|  <b>適航指令發布單</b><br><b>Airworthiness Directive Issuance Form</b>  |  |
| 民航局 AD 編號<br>AD number  | CAA-2015-06-008 修訂<br>發布日期<br>Date issued<br>2016/1/14   |
| 主旨摘要  | Oxygen - Chemical Oxygen Generators - Replacement  |

## ATA 35 – Oxygen – Chemical Oxygen Generators – Replacement

Appendix 1 – Passenger Oxygen Generator Date of Manufacture

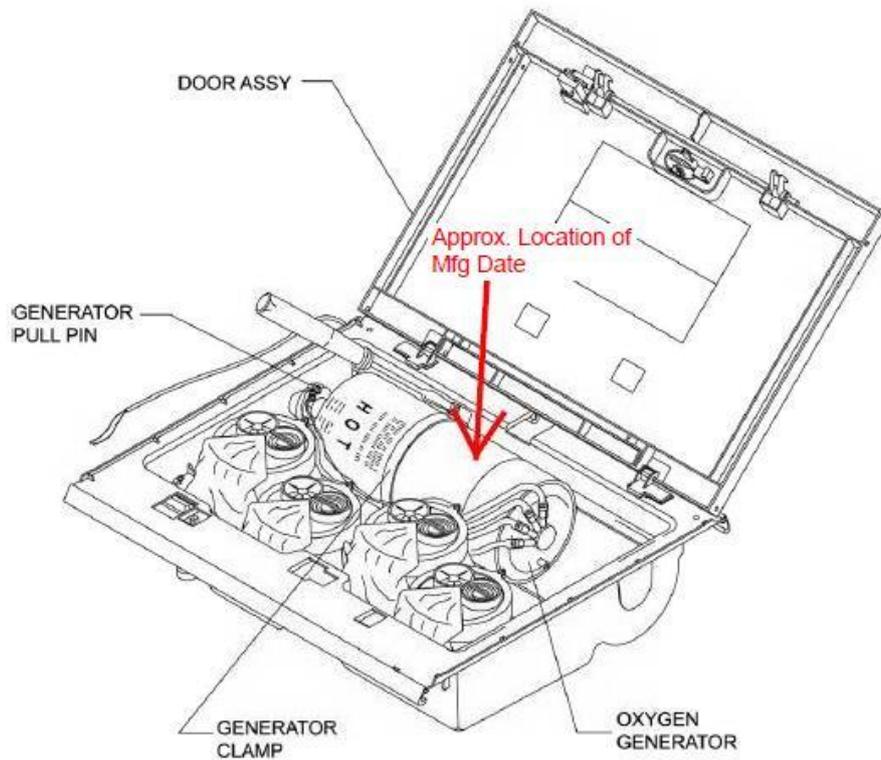
- (1) Within 30 days after 24 December 2014 [the effective date of EASA AD 2014-0277], identify the date of manufacture (see Appendix 1 of this AD where this is located) of each oxygen generator, having a P/N as listed in Table 1 of this AD, in accordance with the instructions of Airbus AOT A35L007-14.
